Access Compliance Report

Public Rights-of-Way

Intersection ID: 2959	Main Street: HARBURN_FOREST_DR	Cross Street: TUNSTON_LN	Location: SW
ADA ID: 66F67FCE45ED	Ramp Type: PerpDiag	Initial Pass/Fail: Fail	Overall Compliance: No Severity Score: 26.25

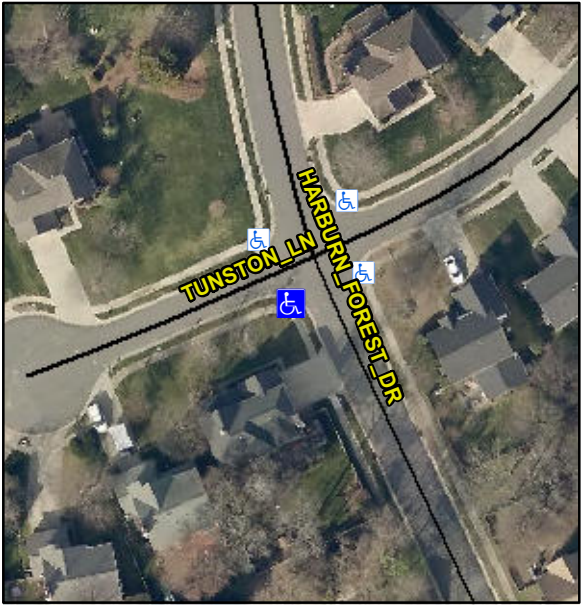
Codes/Mitigation Info/Possible Solution			Field Measurements/Component Compliance		
	Possible Solutions:		Compliance	Description	Data
	Remove & Replace Curb Ramp With Two New Directional Ramps or Equivalent.		No	Ramp Length (in)	46.0
			Yes	Ramp Width (in)	55.0
			N/A	Flare Type LT	N/A
			N/A	Flare Slope LT (%)	N/A
			N/A	Flare Traversable LT?	N/A
			N/A	Landing Length (in)	N/A
			N/A	Landing Width (in)	N/A
			N/A	Landing Slope (%)	N/A
			N/A	Landing X Slope (%)	N/A
<p>Surveyor Notes:</p> <p>N/A</p> <p>PROW/ADA:</p> <p>Not Found, R304.2.2, R304.5.3</p>			N/A	Flare Type RT	N/A
			N/A	Flare Slope RT (%)	N/A
			N/A	Flare Traversable RT?	N/A
			N/A	DWS Provided?	N/A
			N/A	DWS Contrast?	N/A
			N/A	DWS Length (in)	N/A
			N/A	DWS Full Width?	N/A
			N/A	DWS Offset (in)	N/A
			N/A	Shared Landing?	N/A
			N/A	Gutter Ponding?	N/A
			N/A	Gutter Lip Ht (in)	N/A
			N/A	Painted X Walk1?	No
				X Walk 1 Direction	To E
			N/A	X Walk 1 Width (in)	N/A

X Walk 1 Slope (%)	2.0
				X Walk 1 X Slope (%)	6.9
			N/A	Ramp inside XWalk1?	N/A
				Road Slope (%)	2.3
				Road X Slope (%)	5.2
			N/A	Any Obstructions?	N/A
				Obstruction Type	
Total Cost:		\$ 3200.00			
			N/A		N/A
			Yes	Surface Condition? (G/P)	Good
